GM TECHNICAL ASSISTANCE CENTER (TAC)

Dealer Tips and New Information Newsletter

September 16, 2022

1. FAM 0 Engine (RPO LUV) Intake Manifold Redesign Inspection and Familiarization

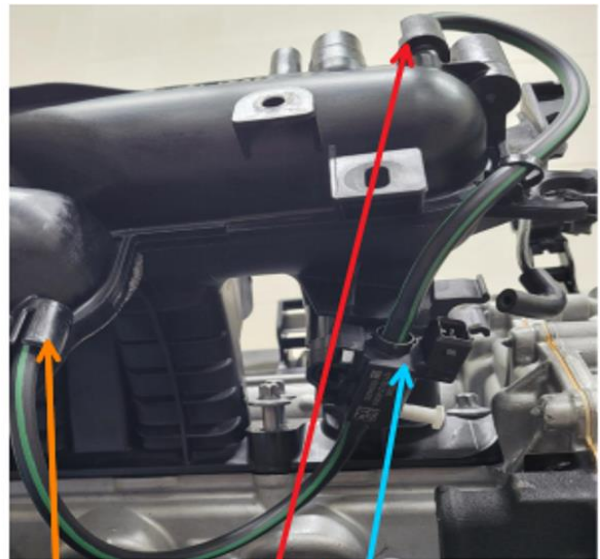
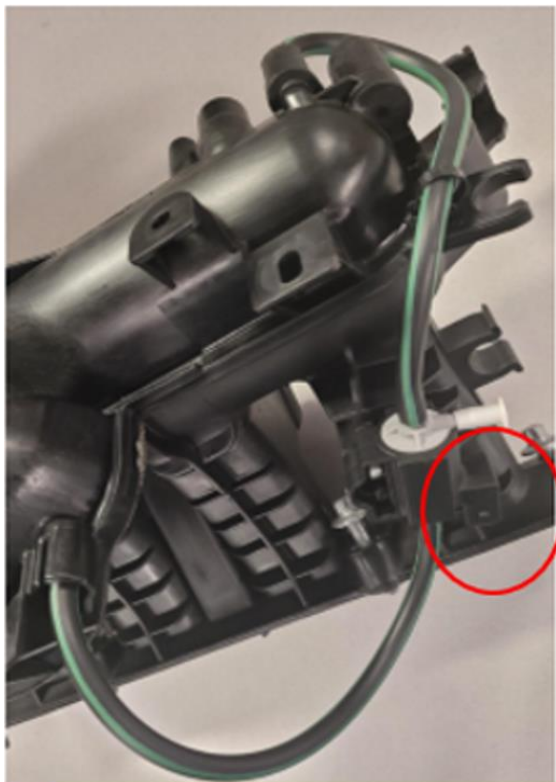
New intake with re-designed Intake Positive Pressure Port Position location. Solenoid location is electrical connector forward. Vacuum feed is in the same location.

If the solenoid is found to be loose, review the location of the electrical connector. If the connector is facing the cylinder head, it is installed backwards and will need to be removed and installed correctly.

Solenoid- Incorrect install- retainers not seated connector facing cylinder head Keyed section of intake not level with solenoid body

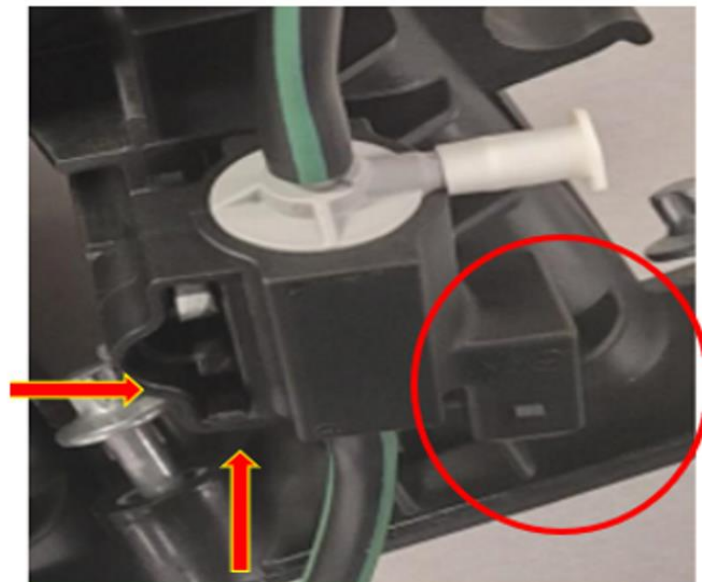
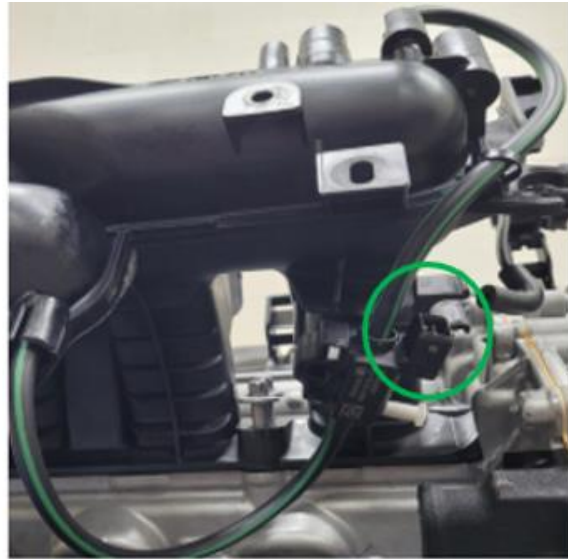
(Above) New Design - incorrect solenoid installation.

Note the electrical receptacle location. Remove and reinstall the lines and solenoid as they are retained to the intake if installed incorrectly. Tabs reversed. The solenoid is keyed and will not be seated in retainers.

New Design - correct solenoid installation correct connector positioning

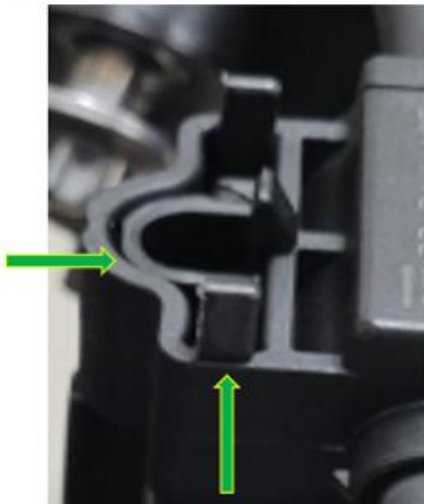
Solenoid connector correct installation retainers latched Keyed section of intake almost even with solenoid

Correct and seated
